Addendum No. 1

Project Name: N5001(1)1,2&4 Road Improvement Project in Toadlena/Two Grey Hills, NM

Owner: Navajo Division of Transportation

3. Plans: Sheets 98-102 have been revised to clarify dimensions for Bridge N213 per question received. Replace plan sheets 98-102 and refer to the question-and-answer section.

GRS-IBS-DETAIL
SHEET 1 OF 4

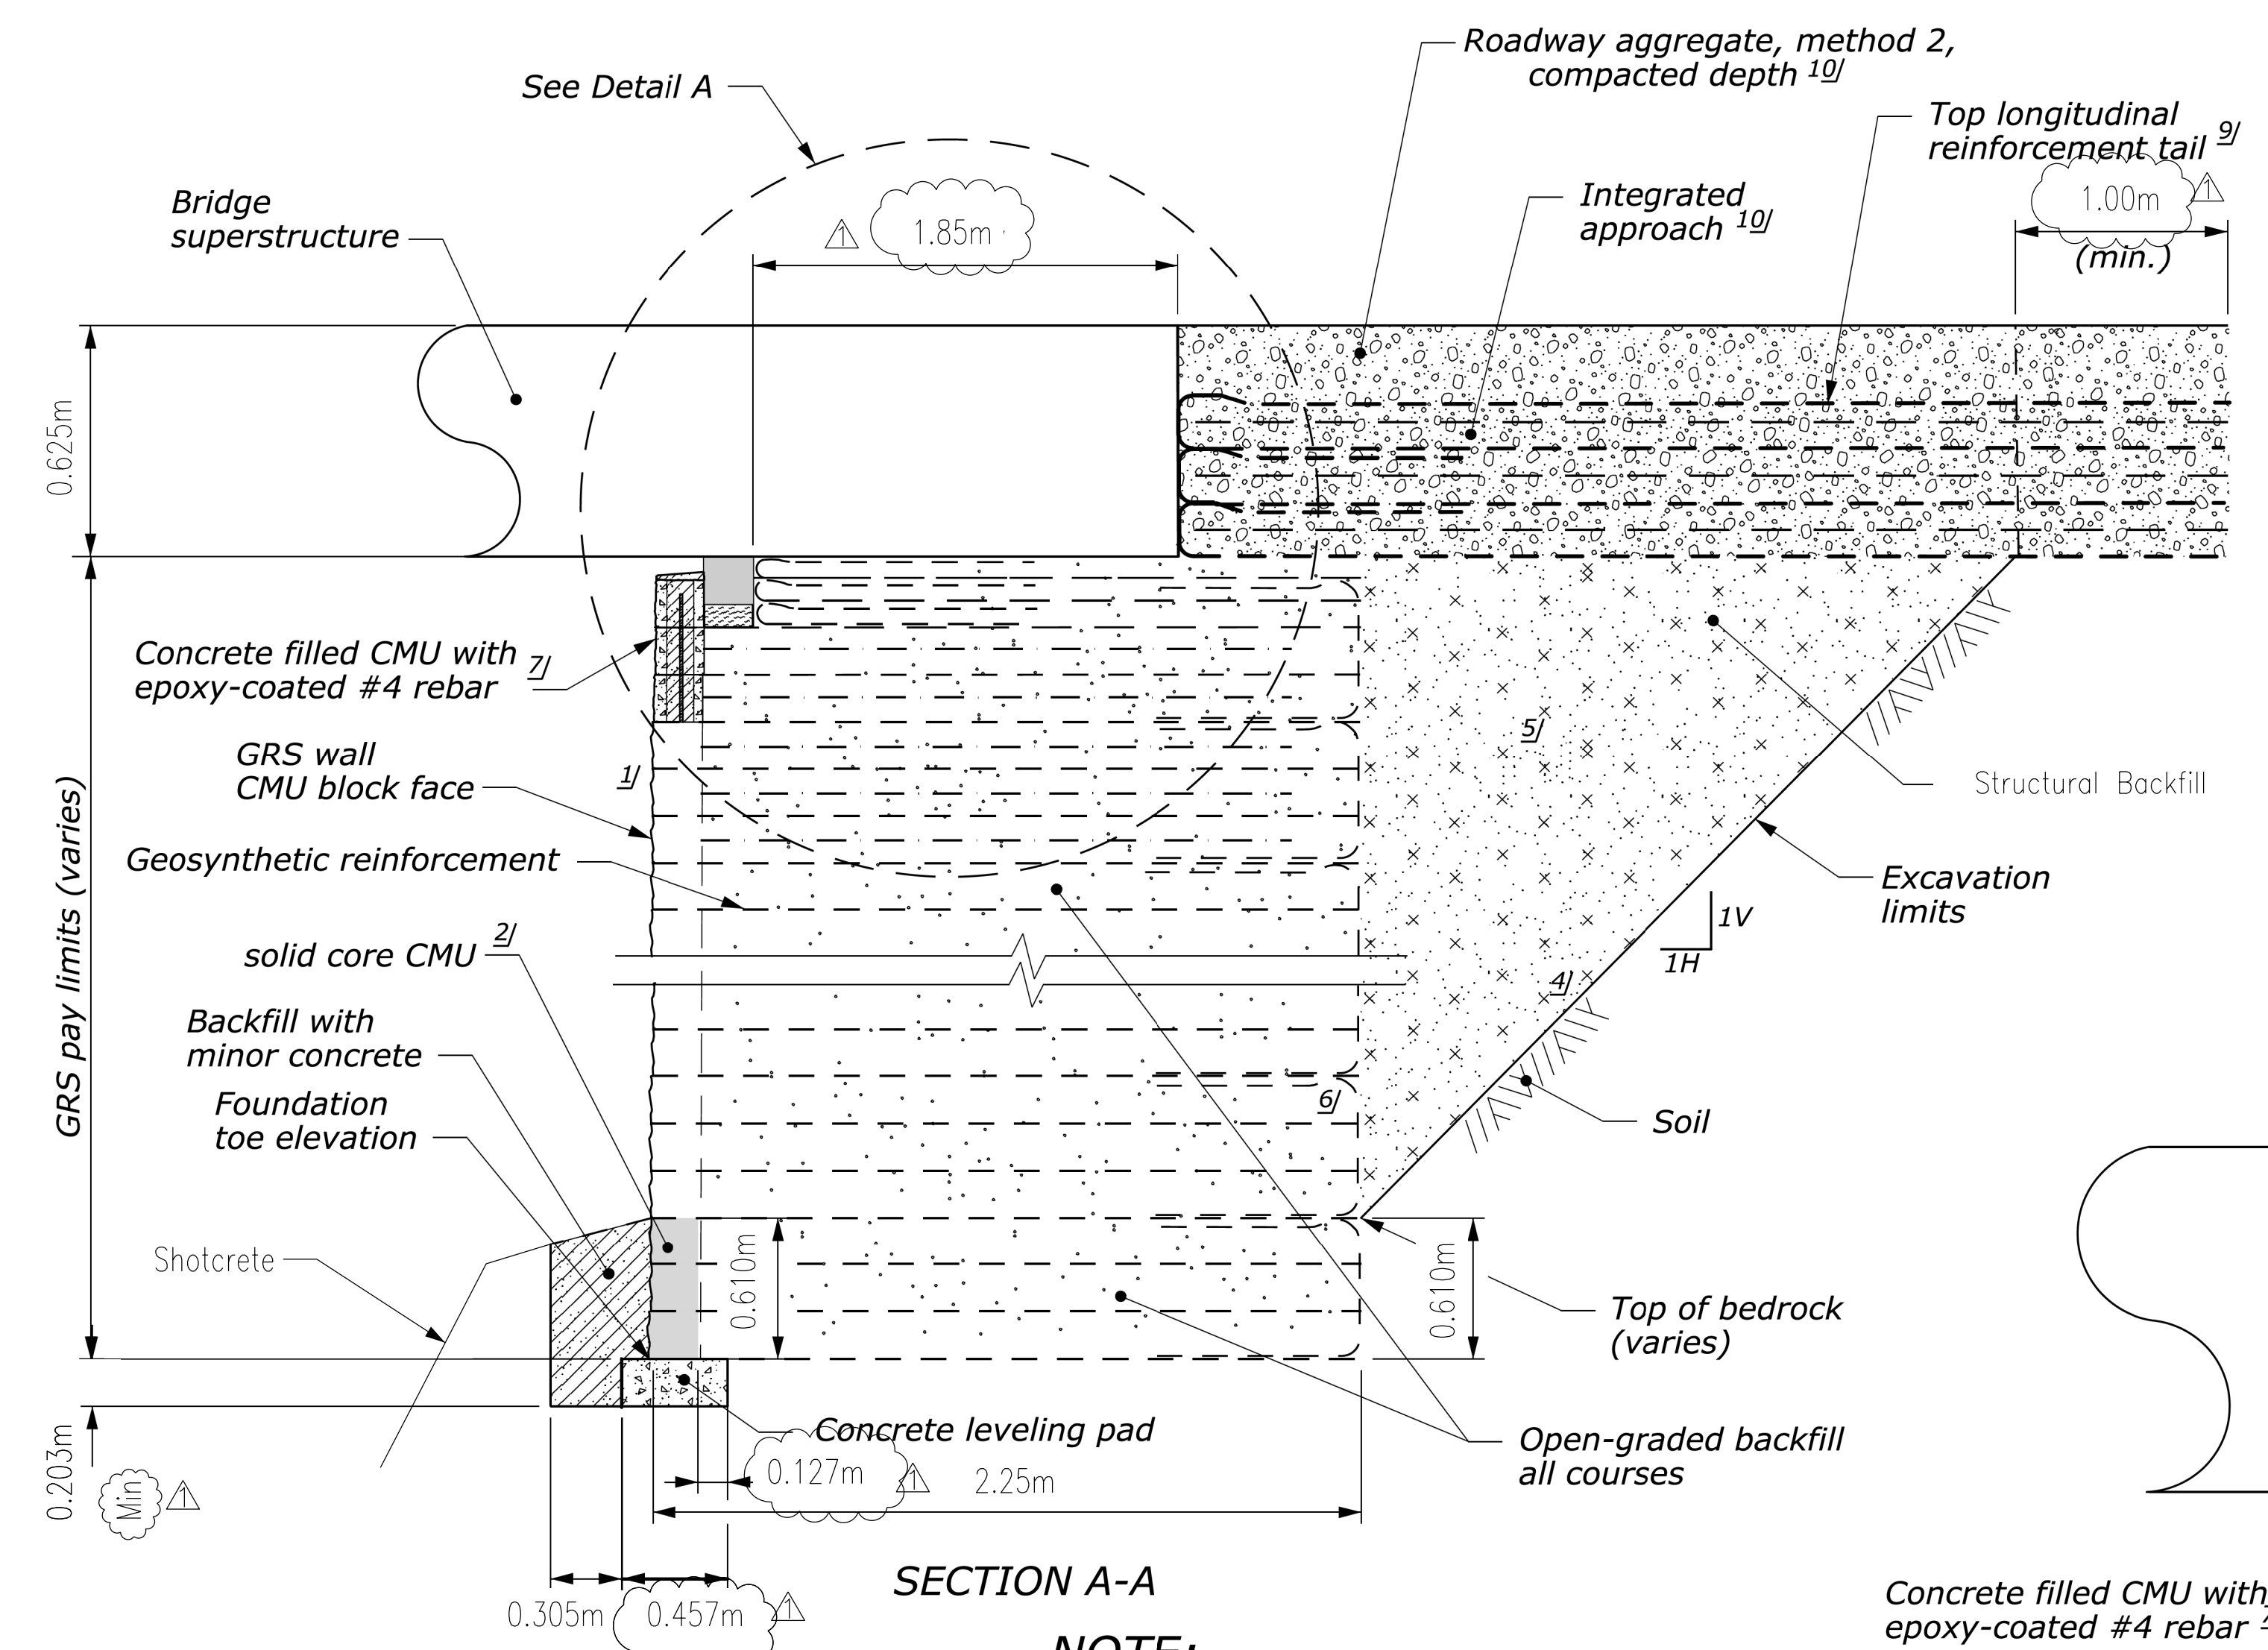
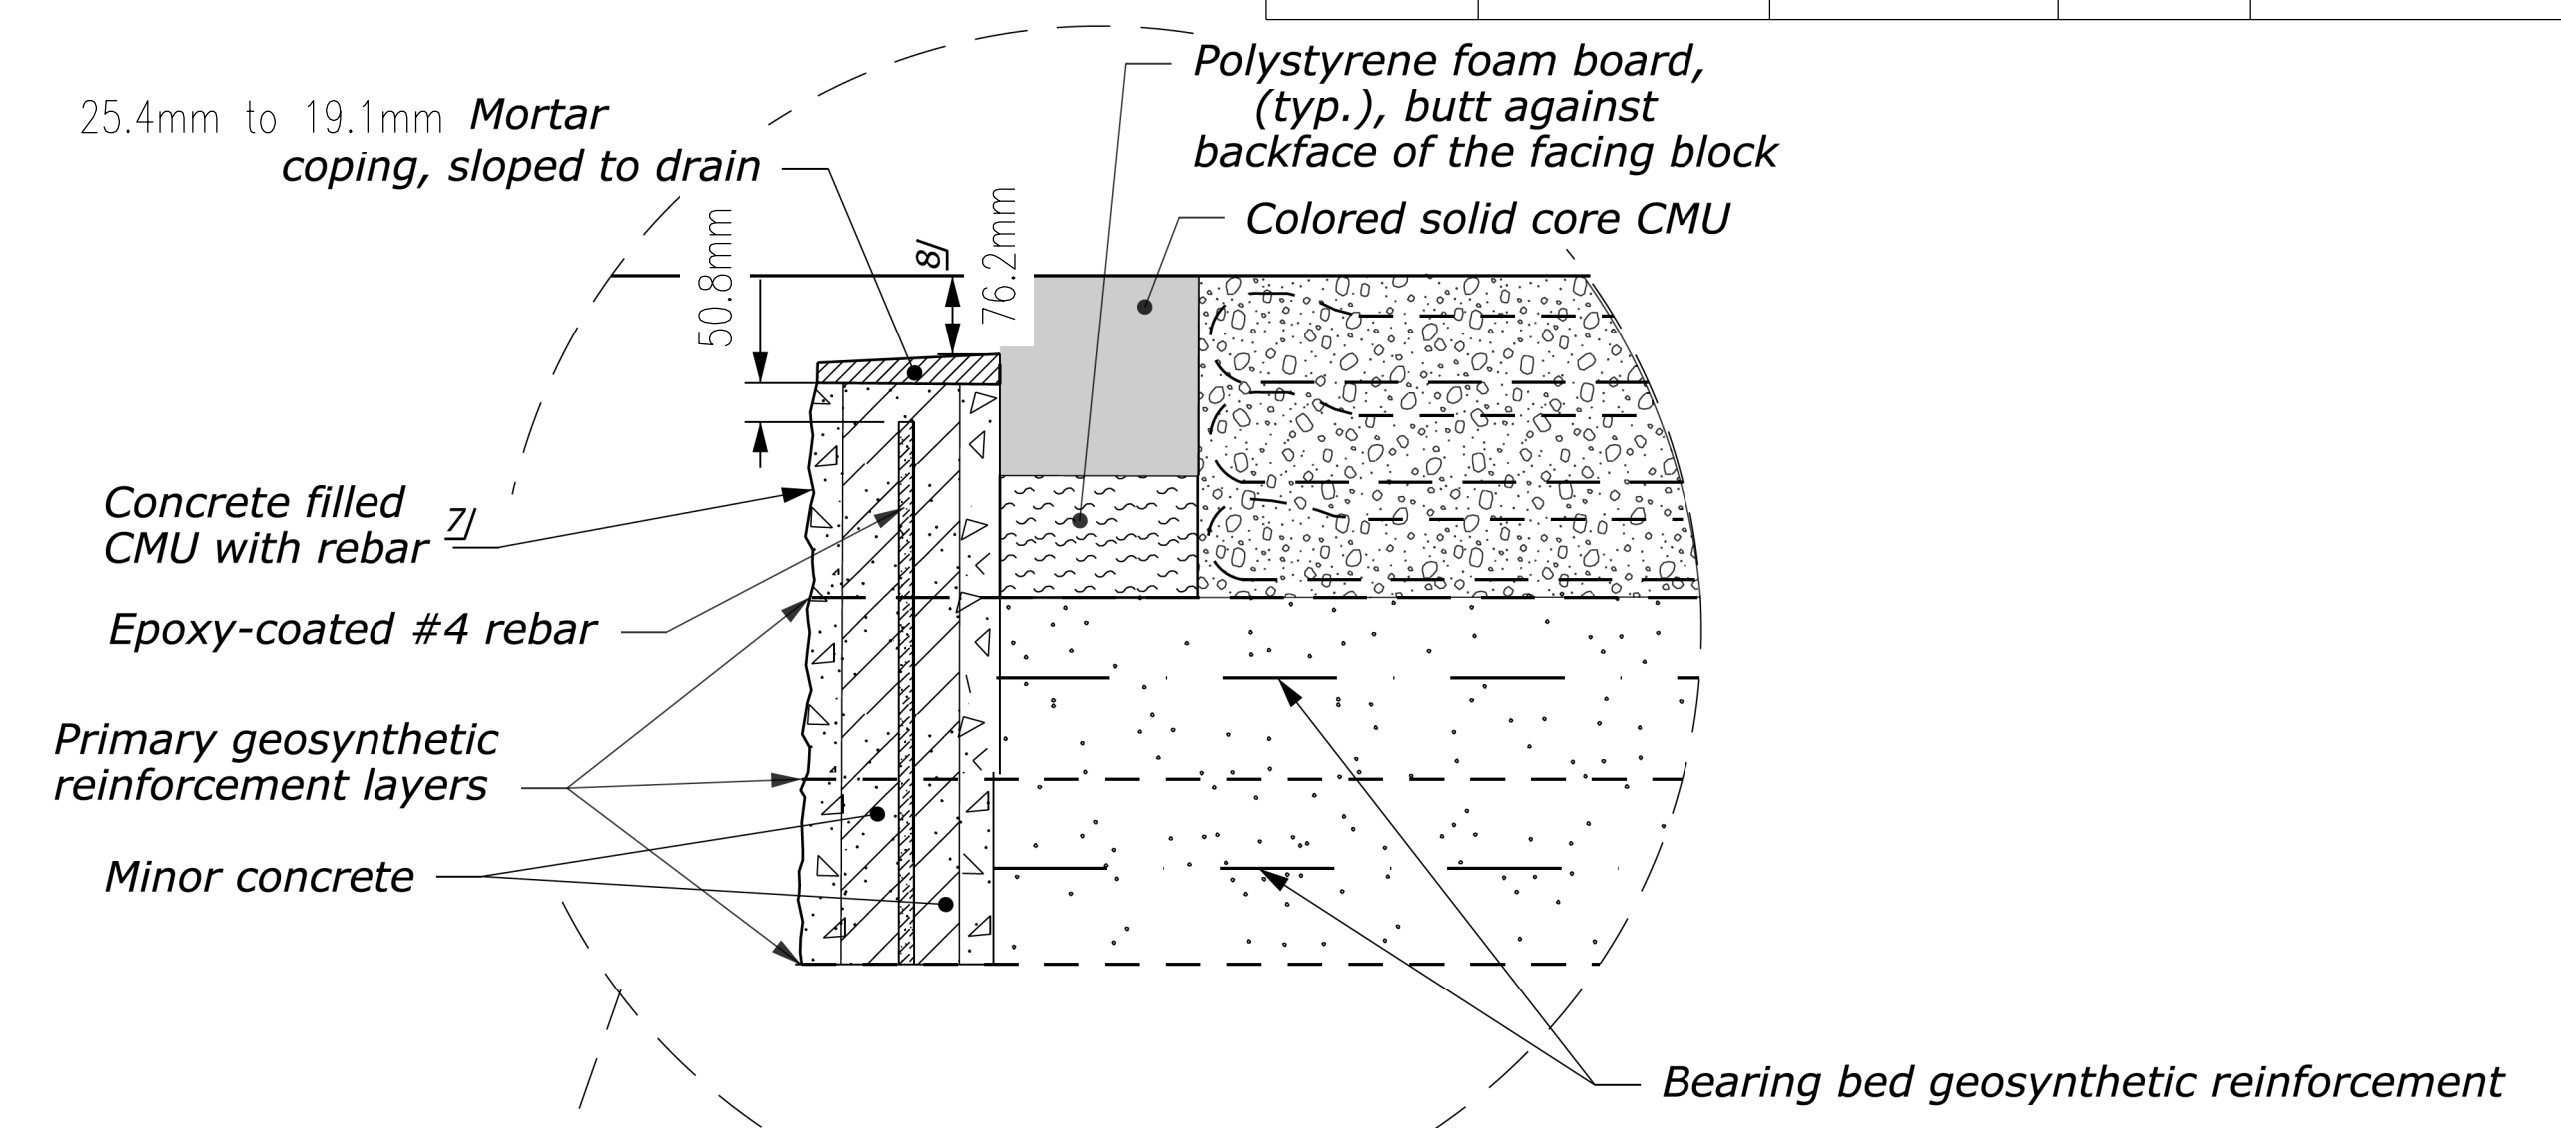
<p>Will the department please verify the dimensions of the concrete leveling pad on structure 213. Plan sheet 99 is showing a width of 2.820 Meters. Additionally, the height of the leveling pad is referenced as</p>	<p>The depth of the leveling pad is to be 0.203m minimum to 0.500m maximum. The width of the leveling pad is to be 0.457m.</p>

.203 M on sheet 99 and on sheet 98 it is referenced as 500 MM max.	Plan sheets 98 thru 101 have been revised to reflect these dimension clarifications.
Will the department please provide a breakdown of the items that are to be paid for under bid item 20304-1000 (Removal of structures and Obstructions).	See the attached table of items that are to be included in Bid Item 20304-1000 Removal of Structures and Obstructions.
Note 8 (Removal of Existing Bridge) on plan sheet 93 of the project plans states that the contractor shall remove, clean and stockpile all existing salvageable material. Will the department please provide a list of the material that is to be salvaged for both bridges.	Contractor is not to salvage any of the bridge components. Contractor to remove and dispose of all existing bridge components. Please reference Plan Sheet 3, General Note 20 for additional direction on salvageable items.
